UNITED STATES PATENT AND TRADEMARK OFFICE

10/727,096

Office Action Summary	Application No. 10/727,096	Applicant(s) SWANSON, DAVID K.	
	Examiner Aaron Roane	Art Unit 3769

**Figure A**

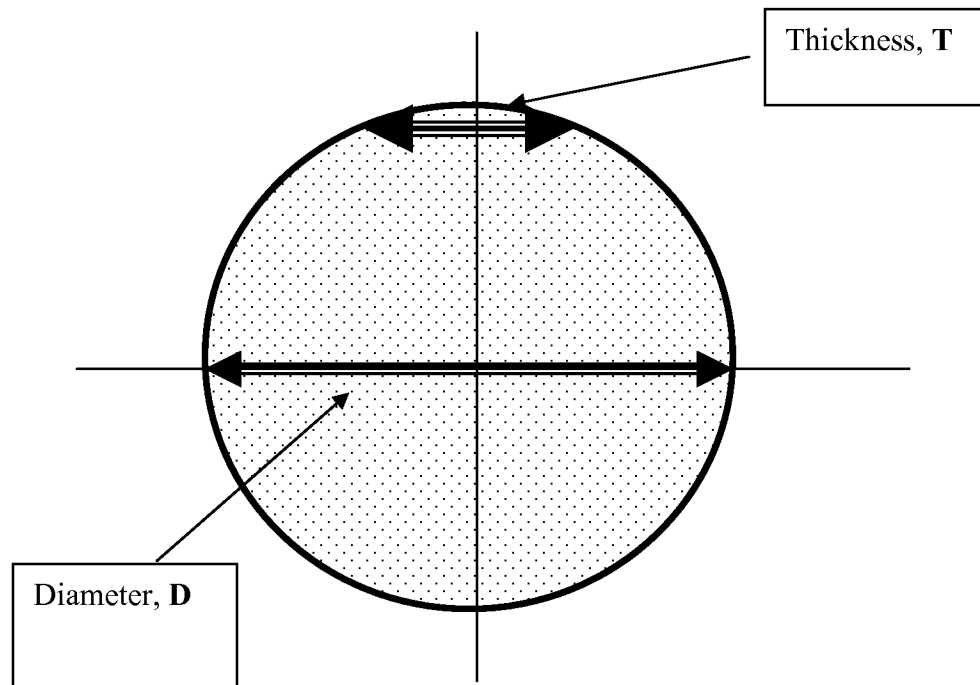
Regarding claims 31-33 and 37-39, Samson in view of Geeham in further view of Lundback disclose the claimed invention except for the stimulation element defining a perimeter of about 1.5 mm to 3 mm, a thickness of about 0.01 mm and a diameter of about 0.5 mm to 1.0 mm. The examiner takes official notice of the perimeter as it is trivial to provide the electrically conductive members, i.e. the electrodes of Geeham with perimeter of about 1.5 mm to 3 mm corresponding to the cross-sectional area of wires (W, see col. 3:65 – col. 4:18 and figure 4) and a thickness of about 0.01 mm in order to electrode with its fully functioning capabilities. It should be further noted that a circular perimeter of 1.5 mm to 3 mm yields a diameter of about 0.5 mm to 1 mm. As Applicant

has traversed the official notice rejection, the examiner now provides a prior art reference which has been cited only to support the previous official notice rejection (see MPEP 2144.03(a-d), particularly 2144.03(d)). Specifically it is the cross-section of the electrode that is relevant for this rejection. Ostroff et al. disclose an electrical tissue stimulating device and provide an electrode having a circular cross-section with diameter of 1-5 mm, see col. 5:351-67 and figure 1. Since the perimeter, **P**, of the electrode cross-section is given by

where **D** is the diameter and **r** is the radius. Therefore, in order for the perimeter, **P**, to be about 1.5 mm to 3 mm, the diameter, **D**, must be about 0.47mm to 0.95mm. Since 1mm is about 0.95mm (a difference of less than 5.3%), the perimeter and diameter recitations have been met. Regarding the thickness of about 0.01mm, it can easily be seen from the **figure A** below, given a circular cross-section, a thickness can be defined which the circular cross-section inherently has and that is about 0.01mm. Figure A depicts the electrode's circular cross-section having a diameter, **D** and thickness, **T**. It should be noted that thickness of 0.01mm is located almost at the top of the cross-section and for further illustration it should be noted the distance from the center of the circular cross-section to where the thickness is 0.01mm is equal to the square root of $(0.5\text{mm})^2$ minus $(0.005\text{mm})^2$.

Finally, Applicant may argue Geeham doesn't disclose a circular cross-section. The examiner counters with the fact that a portion of the cross-section is circular (the upper portion) and it is that portion that defines (in view of the official notice and Ostroff et al. (7,149,575)) the recited dimensions.
